Revision to R.U.D. # 05-005A

MINOR AMENDMENT OF MDP/P.U.D. PLAN

NORTH POINTE SUBDIVISION

SUBJECT: PUD# 05-005A

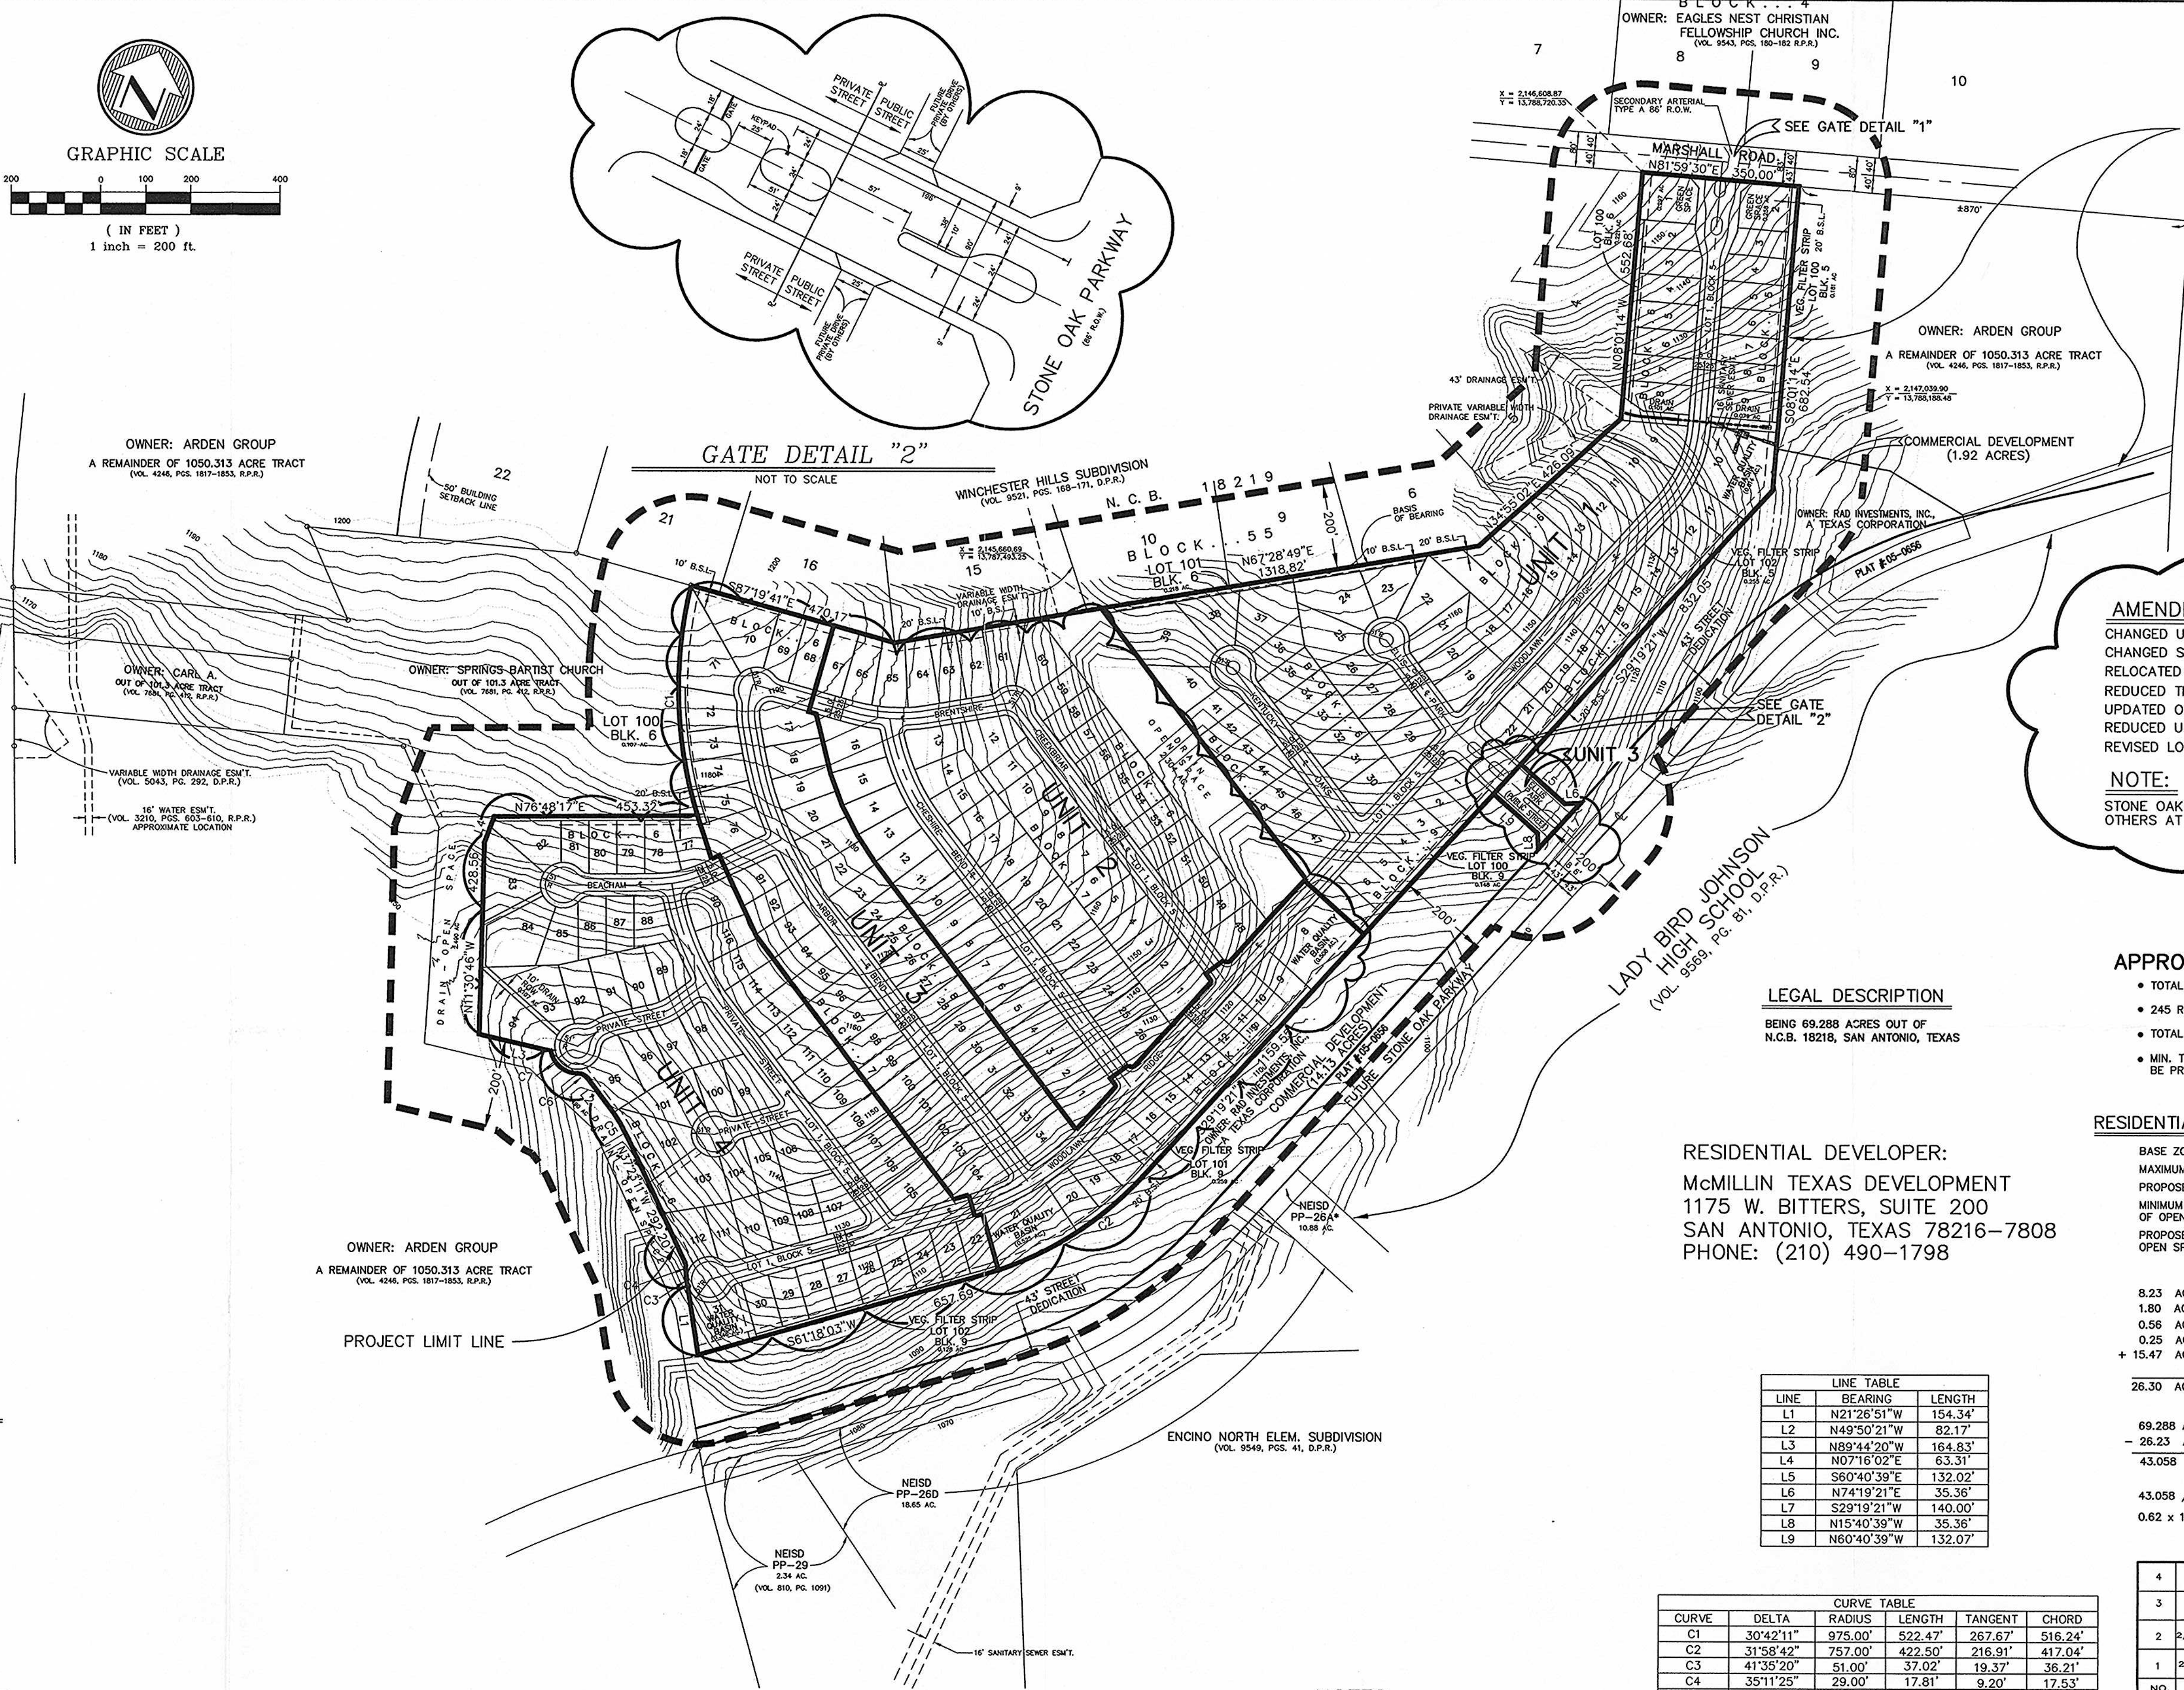
DSD – Traffic Impact Analysis & Streets states: It shall be understood that the submitted MDP Plan is a conceptual plan and therefore this document does not represent an approval for the internal street plan. All streets shall follow UDC 35-506 and the street network shall be planned in order to provide safe and efficient movement of traffic to and from, within and past, the proposed development, while minimizing the impact to non-site trips. UDC 35-506 will be implemented at the time of platting.

- UDC 35-506(e)(3) *Reserve Strips*.
- UDC 35-506 (g) *Dedication of Arterial*.

It should be understood that the submitted TIA is a conceptual plan and therefore this document does not represent an approval for the internal site plan.

- Given the known hydraulic conditions of this watershed at this time, this development is eligible for FILO. Should the dynamics of the watershed change that show “adverse impact” then a reconsideration to provide detention will be considered.

- 100 year Flood Plain Shown and Buffering (If applicable)
- Significant Recharge Features and Buffering (If applicable)
- Category Letter for All Site Specific Plats (If Category 2 or 3, an Aquifer Protection Plan is required (If applicable)
- Additionally, a Water Pollution Abatement Plan or Contributing Zone Plan must be submitted to and approved by the Texas Commission on Environmental Quality (TCEQ) prior to construction.
- Any existing well(s) found on site shall be plugged by the property owner in accordance with SAWS regulations. For plugging procedures please contact Kirk Nixon at 233-3523.
